Technical Bulletin C542

Product: DVD Player

Hardware Technical Bulletin: C542-H2005-03

Subject: Laser ribbon cable

Figure 1

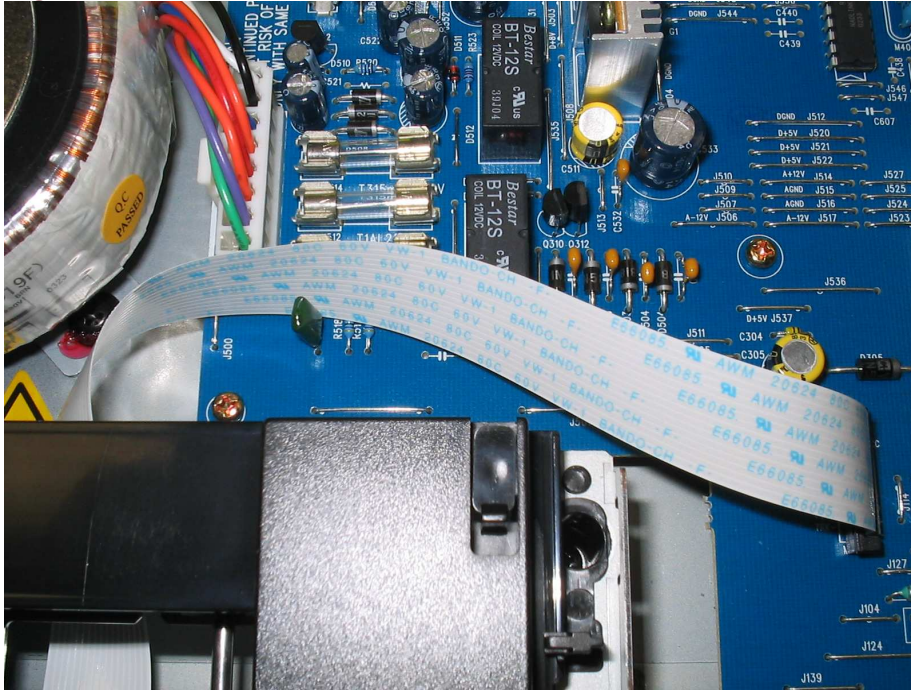
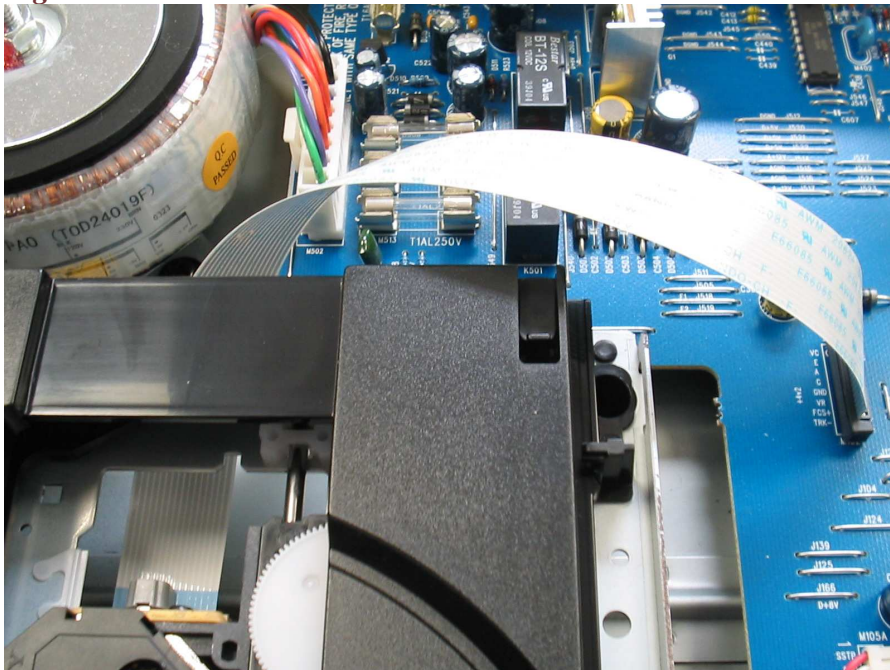
DESCRIPTION: You may have the complaint that some tracks skip or stops playing altogether.

REASON: The laser pick up connects to the main pc board via a flat ribbon cable and is possibly twisted the wrong way . It maybe getting caught on the fuse holders or other parts. just behind the transport mechanism . See figure 1.

SOLUTION: The ribbon cable needs to be allowed to wrap smoothly as shown in figure 2.
